**Solana Highlands Revitalization Project  
Environmental Impact Report**

OCTOBER 2018

- **Chapter 2:** Responses to Comments. This chapter includes a list of persons, organizations, and public agencies that provided written comments on the DEIR during, or after, the public review period. This chapter also includes a copy of the comments received by the City during (and after) the public review process for the DEIR and the City's responses to these written comments. Each comment letter is assigned an identifying name and each comment is bracketed and assigned a comment number, which corresponds to a response number.

Figure 8

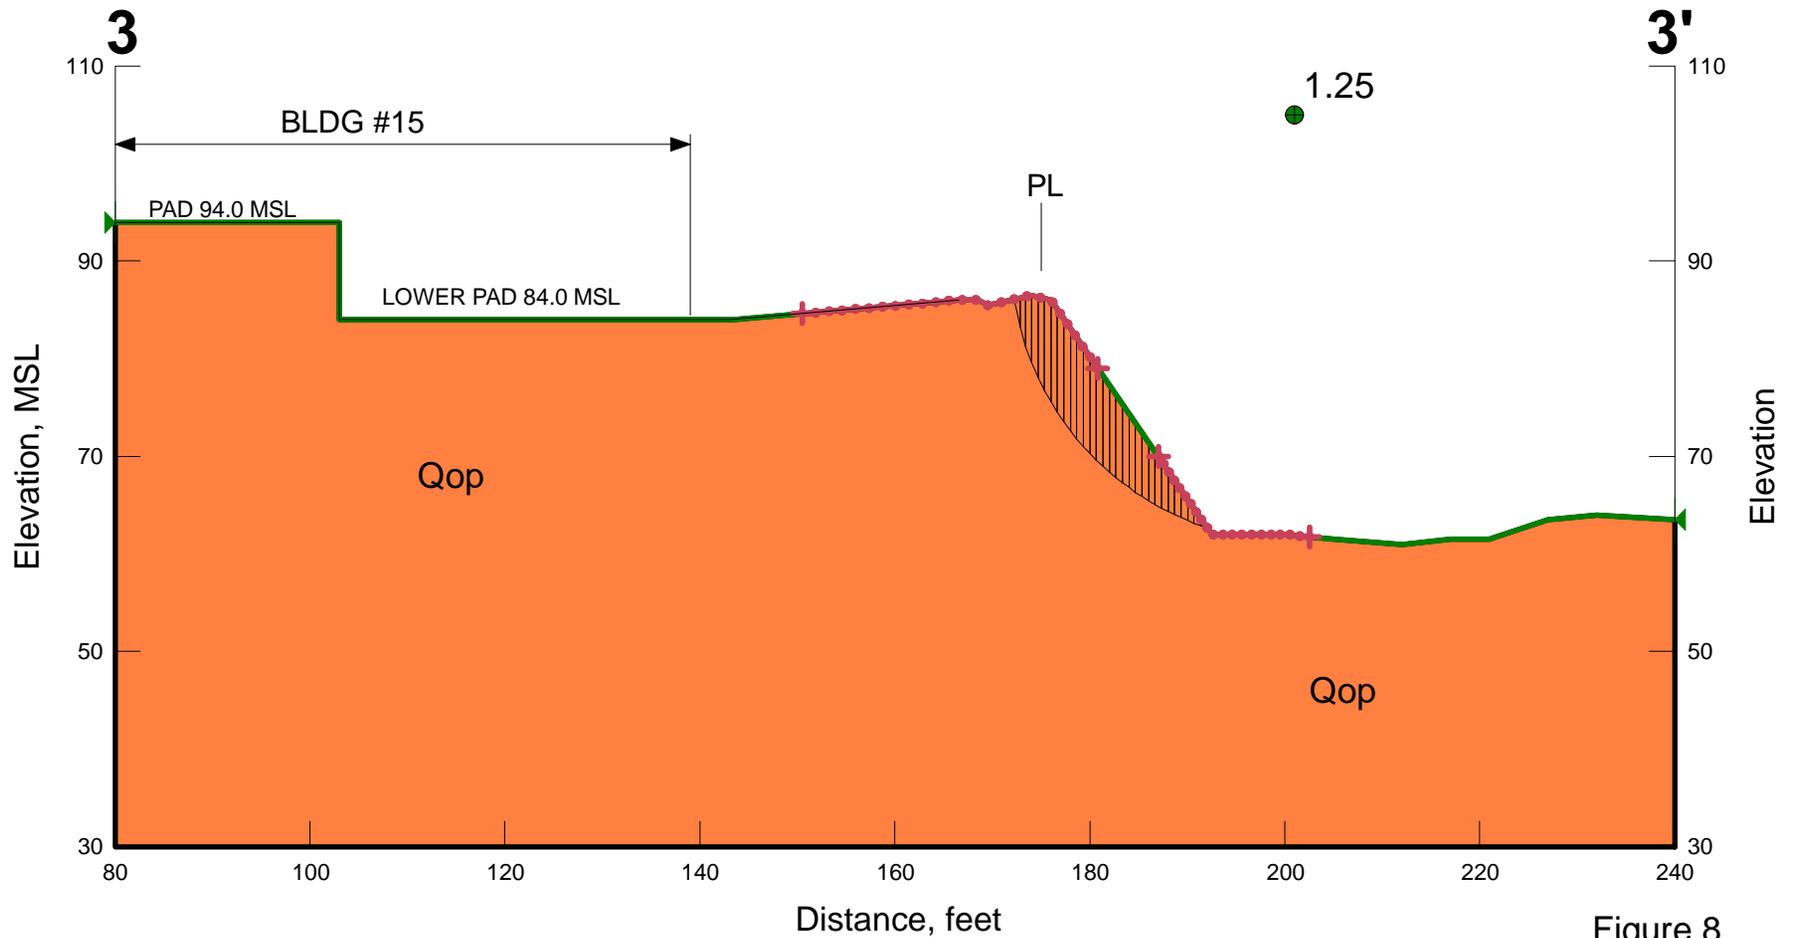
As planned grading consists of cuts at the top of the slope to reach building pad grade, the overall slope condition is improved as a result of soil being removed from the top of the slope, thereby reducing driving forces within the slope zone (see Figures 5, 8, and 9). The factor of safety for the slope increases as a result of the planned grading. With respect to building loading, the buildings are set back at a sufficient distance (at least 1:1 plane from footing to slope face) so imposed loads from the building foundation fall outside of the slope failure plane and do not impact the slope or impose loading within the slope zone.

With respect to the lower steepened portion of the slope south and outside of the property line at the western end of the site (cross section location 3, see Figure 6), the existing slope has a global factor of safety below 1.5. However, the proposed project does not affect this slope. As shown on Figures 6 and 8, the factor of safety remains unchanged between the existing and proposed conditions. The building is set back a horizontal distance of at least 35 feet from the top of the slope, which is a sufficient distance that building foundation loads do not project into the slope failure zone, and thereby, do not impact the existing slope. The failure plane that represents a factor of safety of 1.5 is located approximately 18 feet

Figure 9

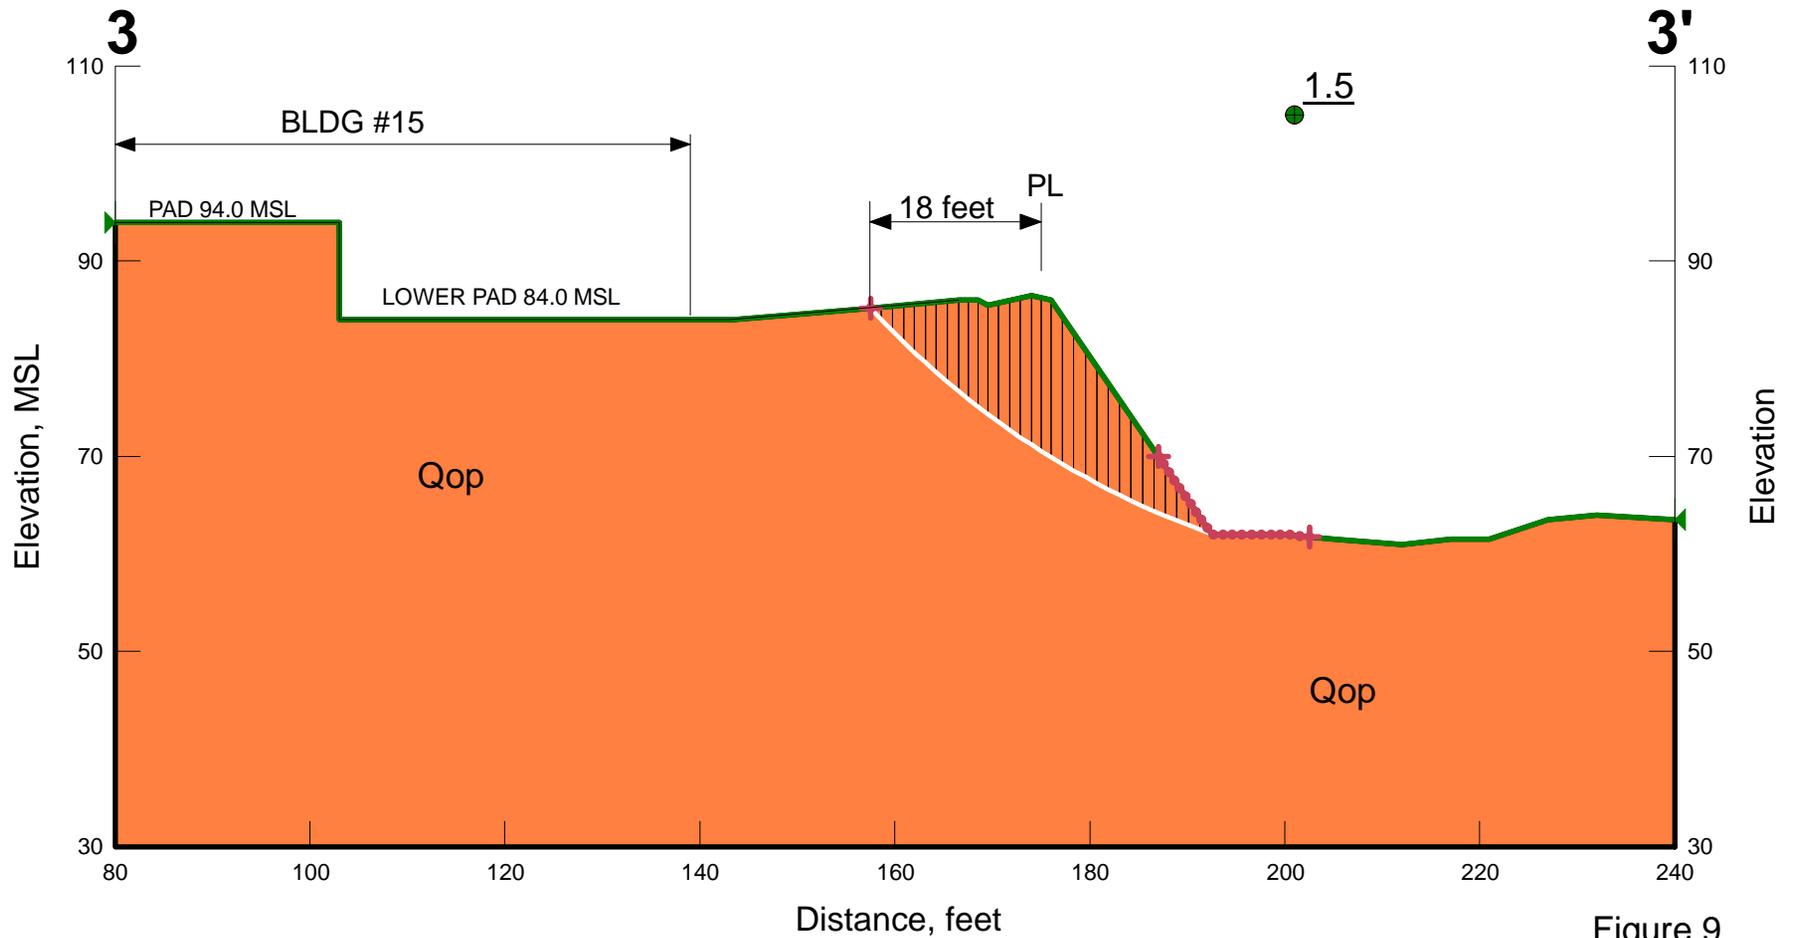
from the property line (see Figure 9). The building is set back 17 feet from this theoretical failure plan, and therefore, slope instability, if it were to occur on the steep slope, should not impact the building.

Figure 10

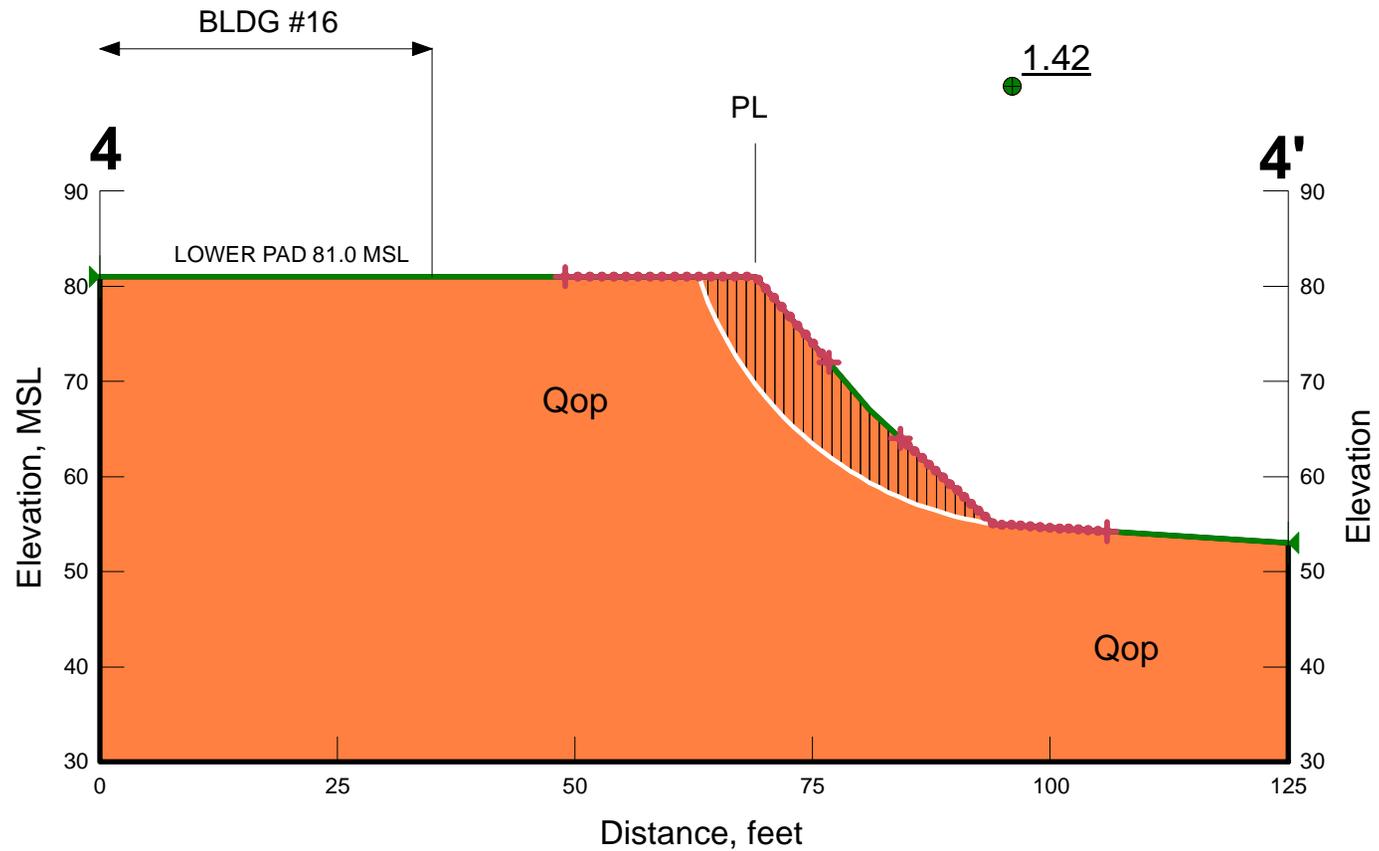
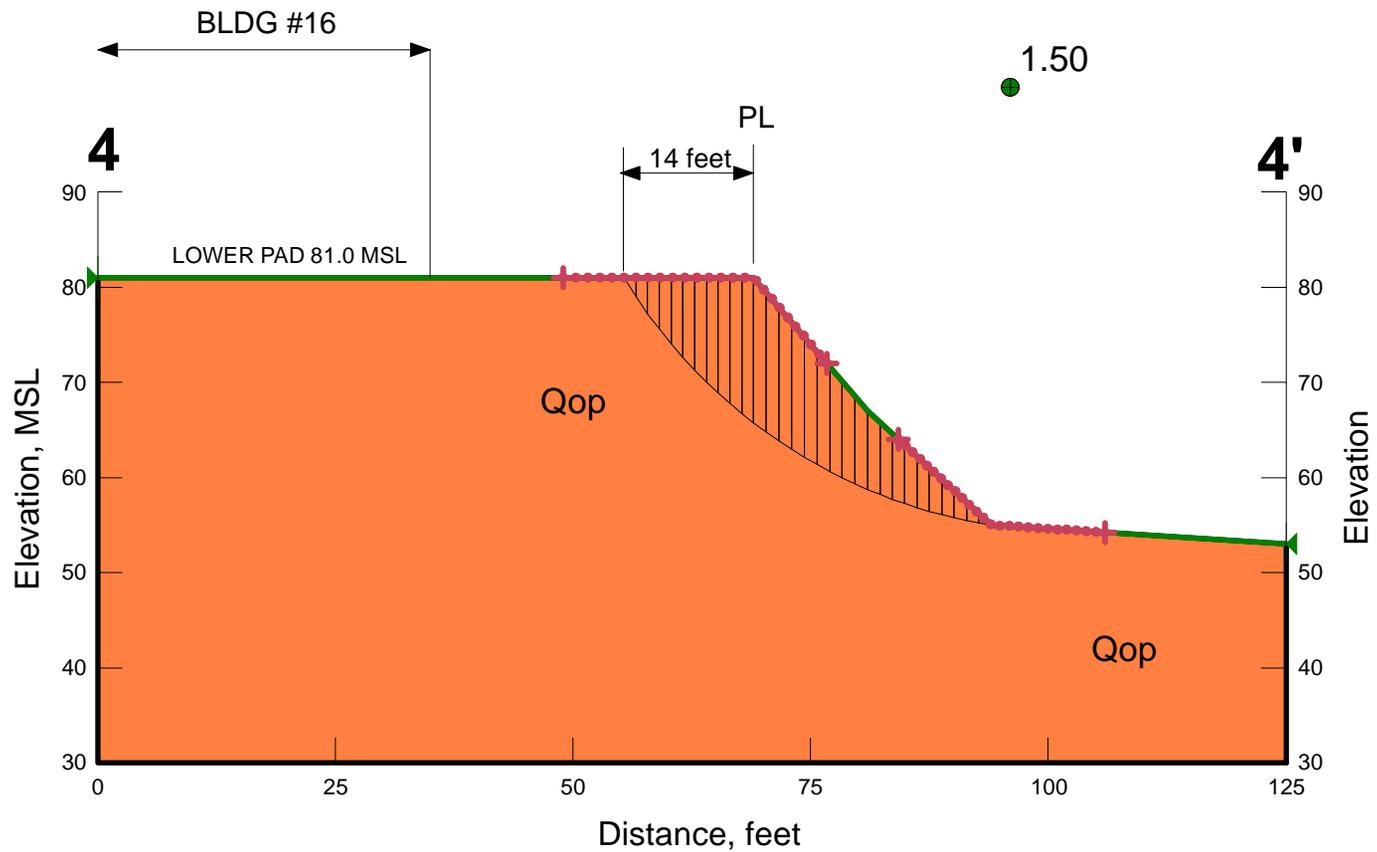
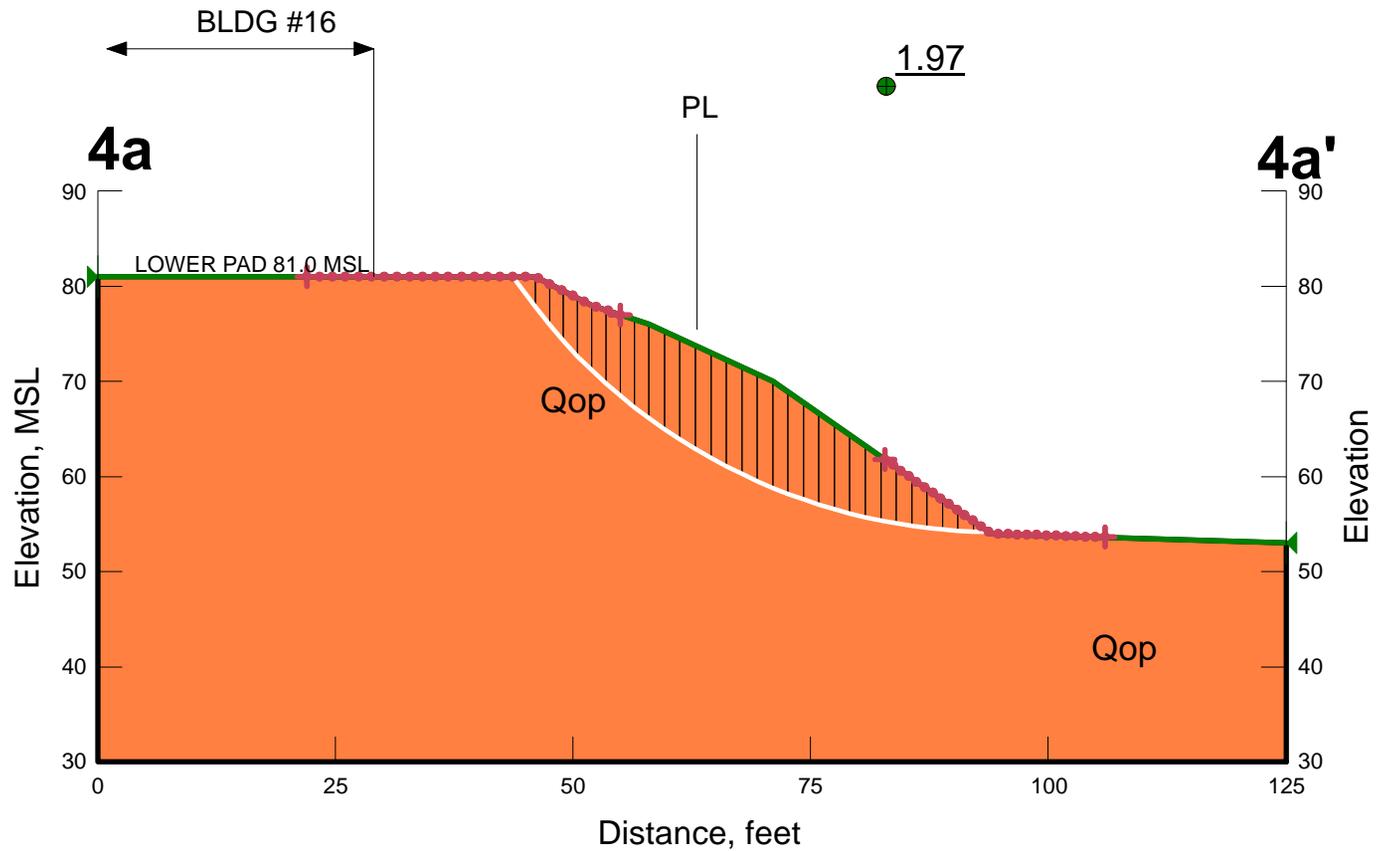
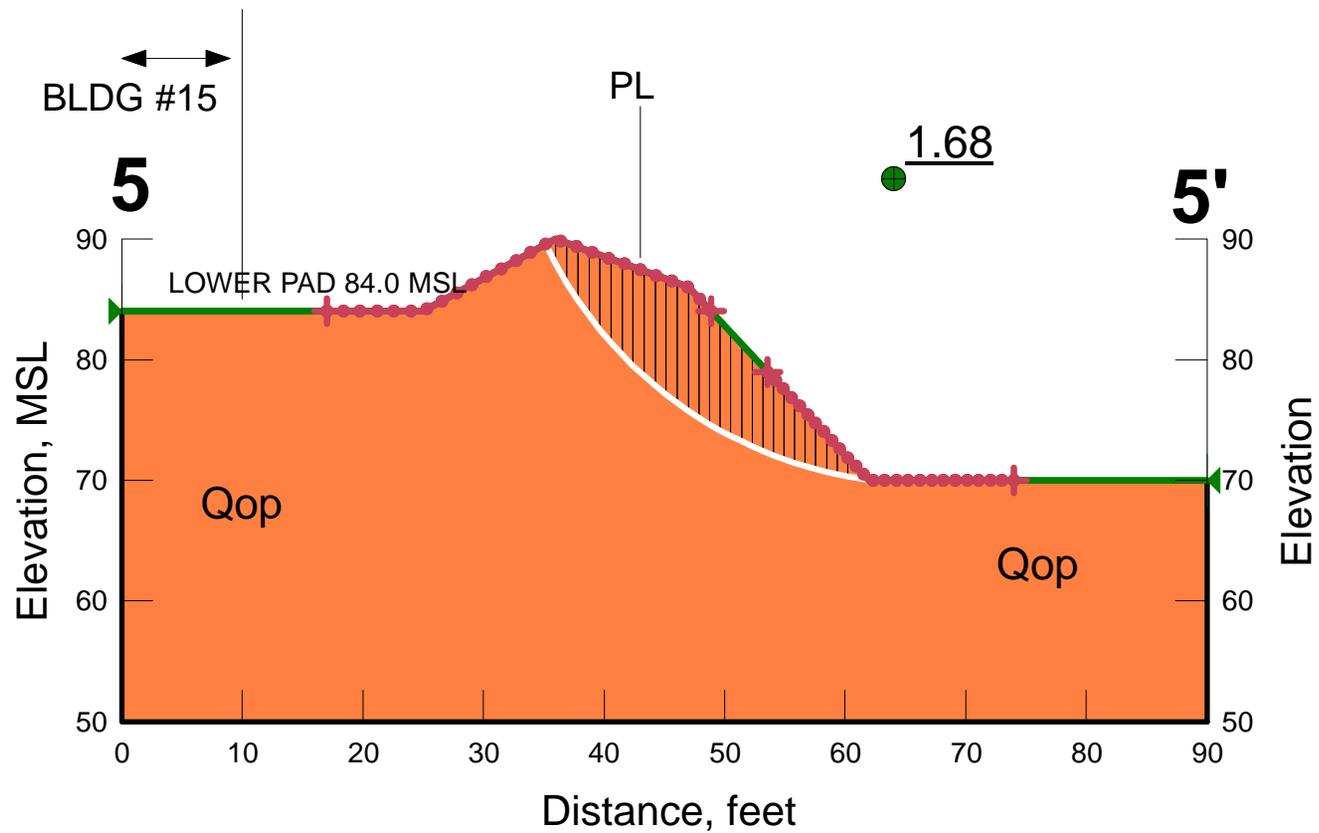
To analyze the approximate limits of the portion of the steep slope that has a factor of safety less than 1.5, we analyzed cross sections 4, 4a, and 5. The results of the stability analysis is presented on Figures 10 through 13. Based on these results, we have identified the slope area that exhibits a factor of safety less than 1.5. This area is shown on Figure 1. We understand the City of Solana Beach will require a structure setback in this area. The northern edge of the setback line is set at the location where the stability analysis indicates a factor of safety of 1.5.
